Town of Brookline

PLANNING BOARD

To: Brookline Board of Appeals
From: Brookline Planning Board
Date: May 14, 2015
Subject: Construct a single-story rear addition totaling 63 square feet
Location: 201 Hyslop Road

Rear Façade (location of proposed addition)

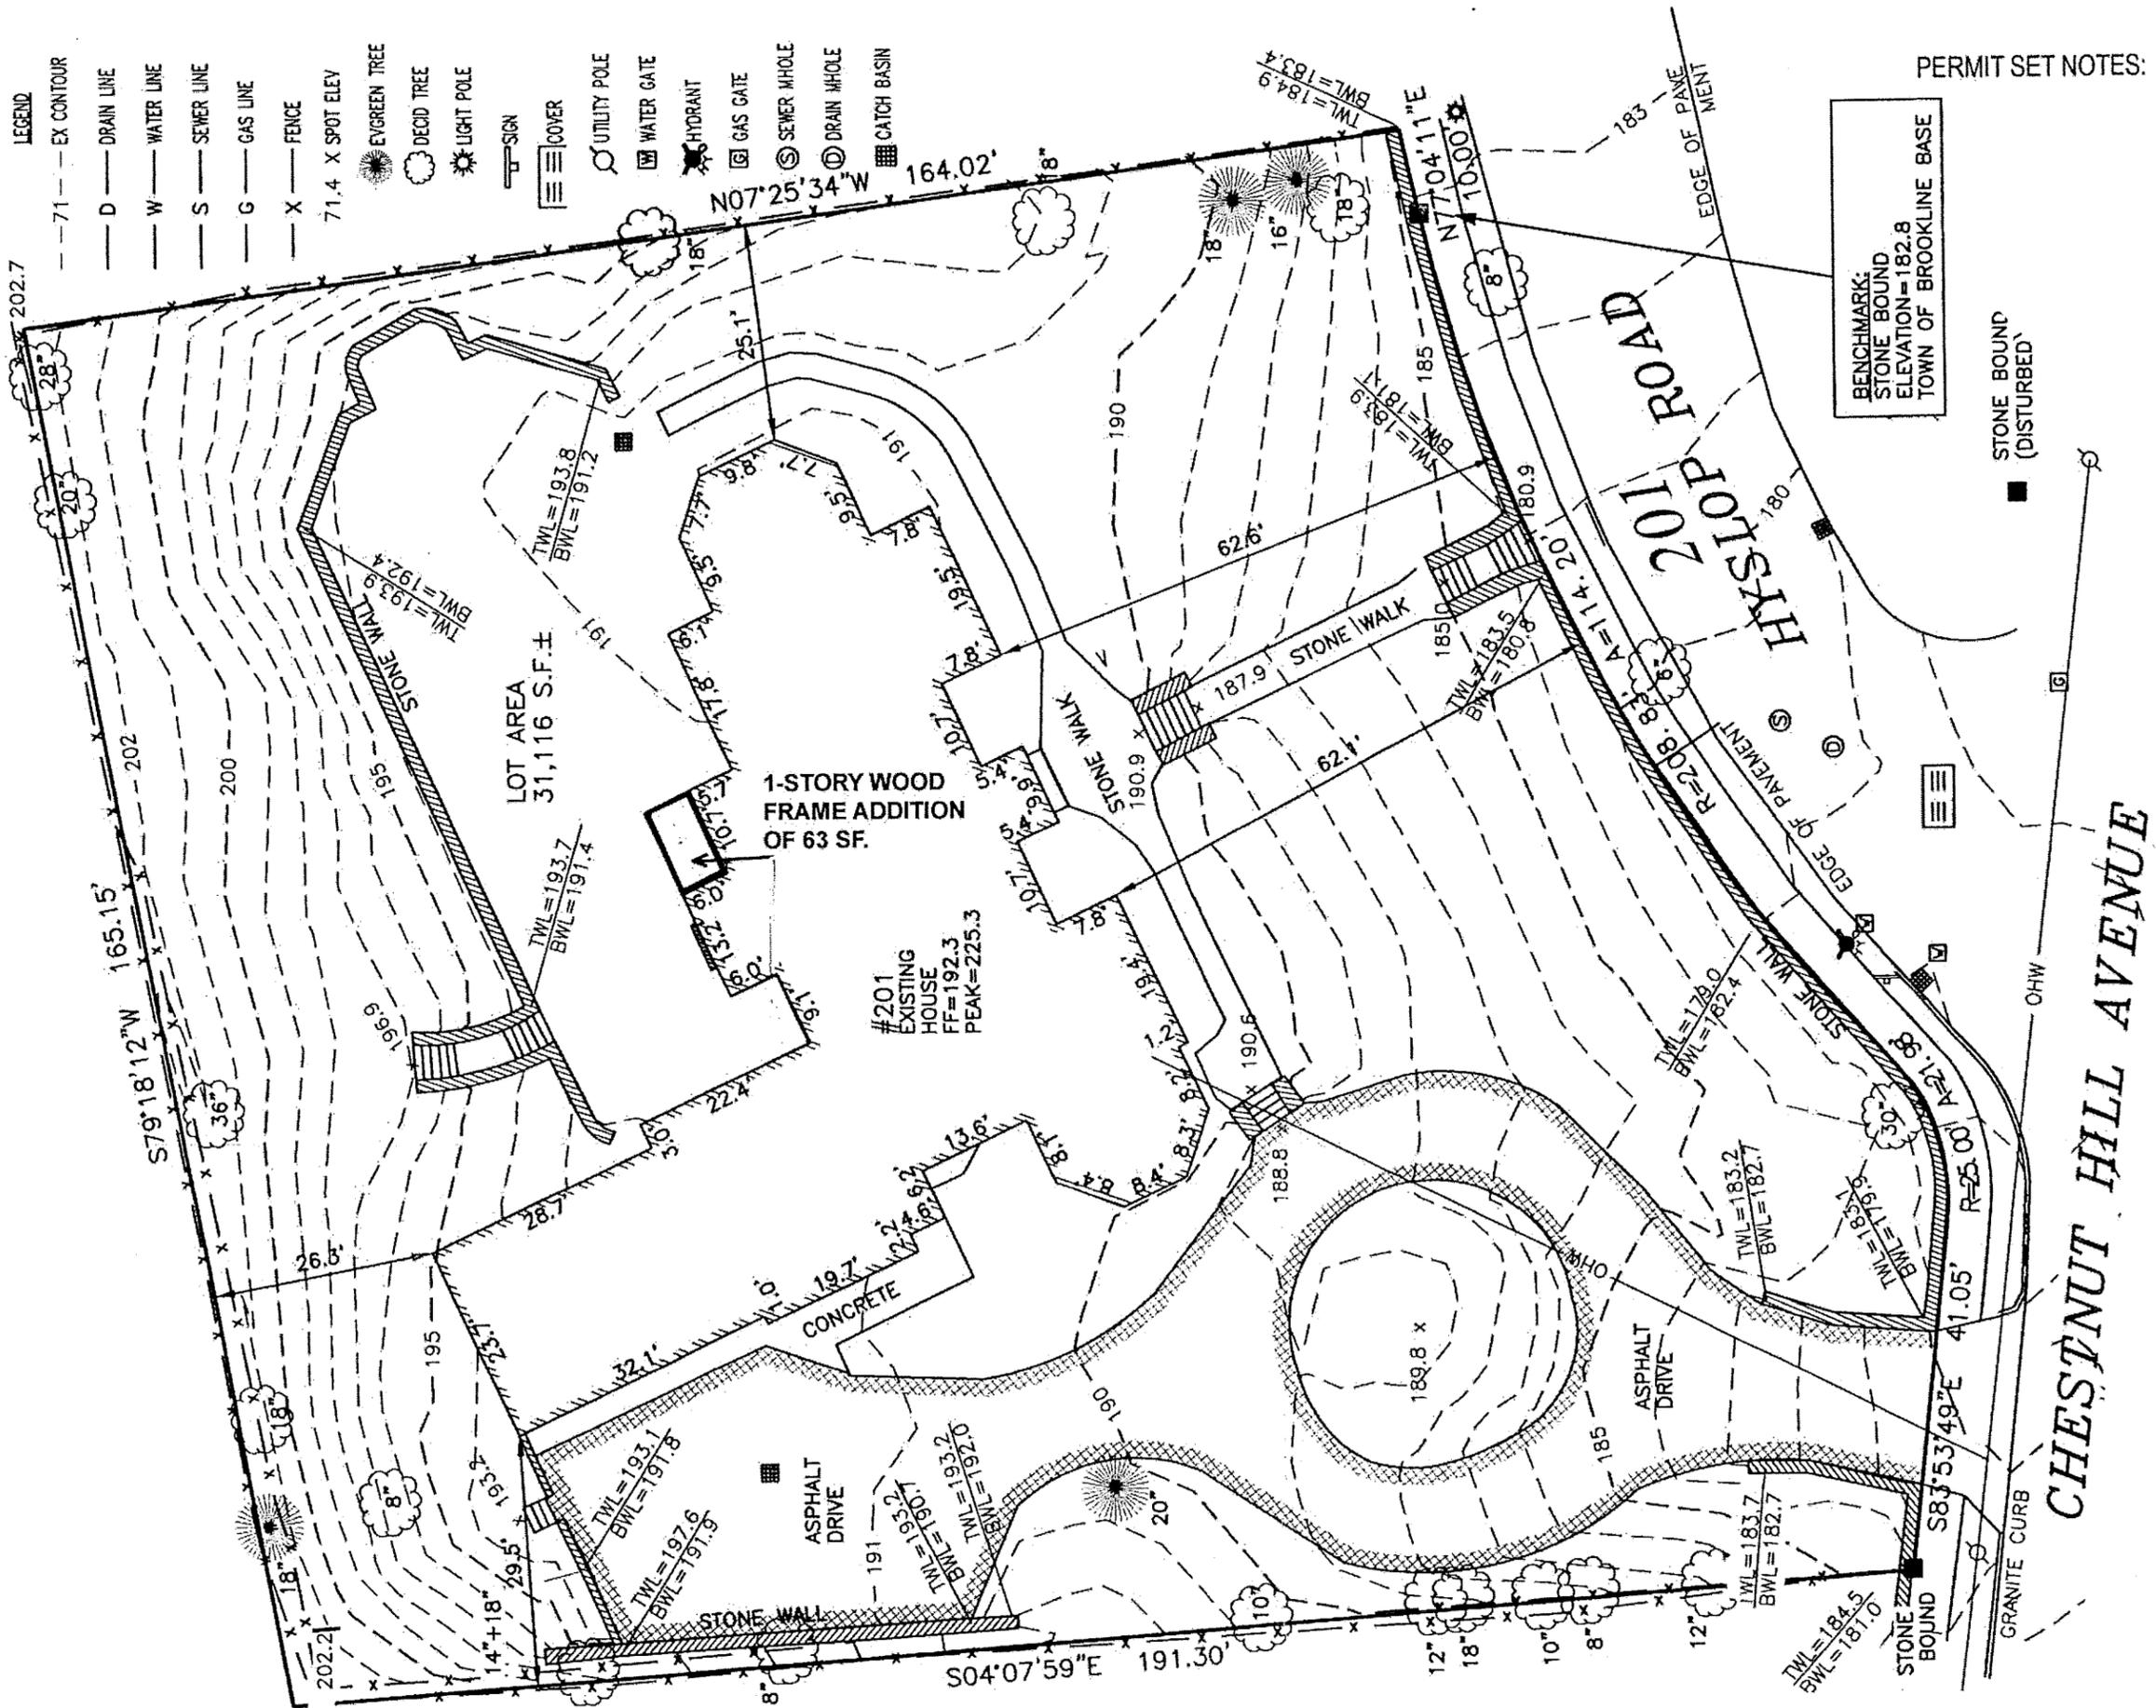
- k. Heritage – The proposed rear addition will conceal two existing rear windows and one door. The Preservation Commission administratively determined that this concealment is not considered to be the demolition of character defining features and therefore does not require further demolition delay review. Additionally, the disruption of exterior character defining features has been minimized as much as practicable during significant renovation of the entire structure.

PROPOSED ELEVATIONS **A6a**

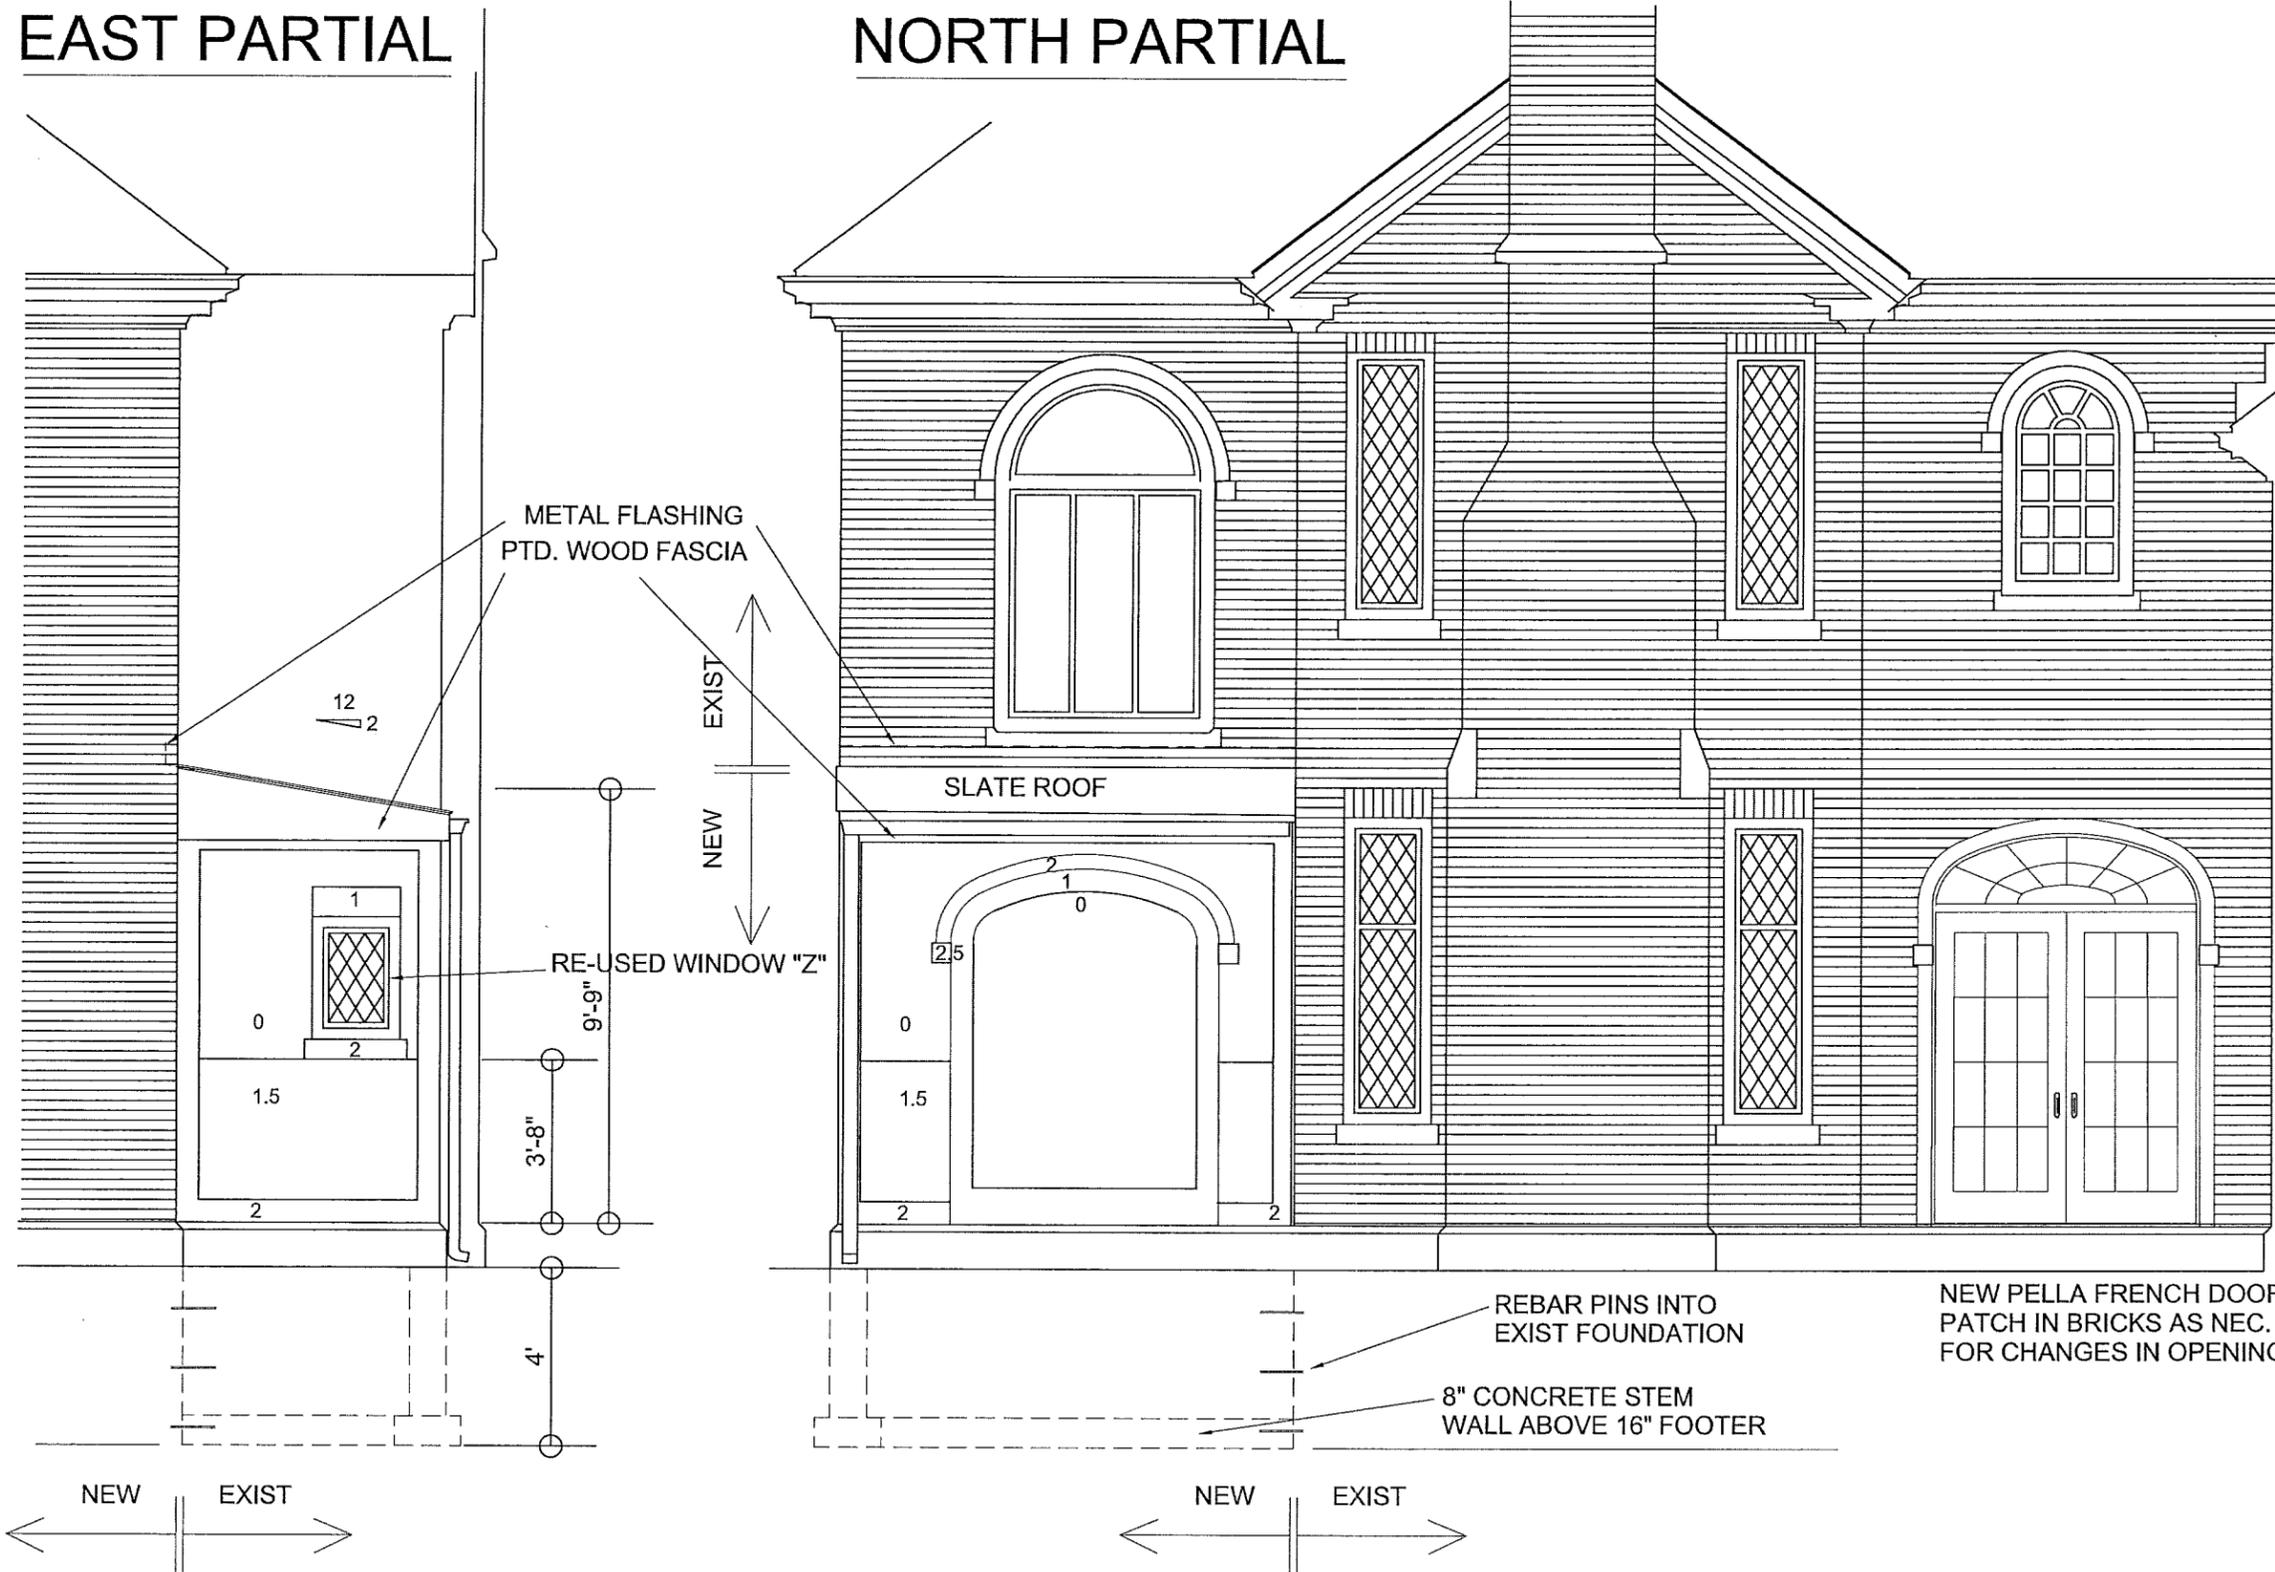
The pitch of the proposed slate roof does not comply with building code regulations. If the applicant wishes to maintain the current pitch of 2/12, then detailed weatherproofing plans or alternate roof materials must be provided prior to the issuance of a building permit.

Additionally, the Planning Board does recommend that the applicant consider wood and clapboard building materials for the addition, as opposed to the proposed molded stucco, because it is more consistent with the design of similar additions to brick structures within the Fisher Hill neighborhood.

The addition will be constructed of a stucco molding with a painted wood fascia and a slate roof [Roof material will be copper in order to comply with building code regulations – roof pitch]. An existing rear window will be reused and included on the eastern face of the addition. This addition will not be visible from Hyslop Road and is screened from rear abutters by existing evergreen and deciduous trees.
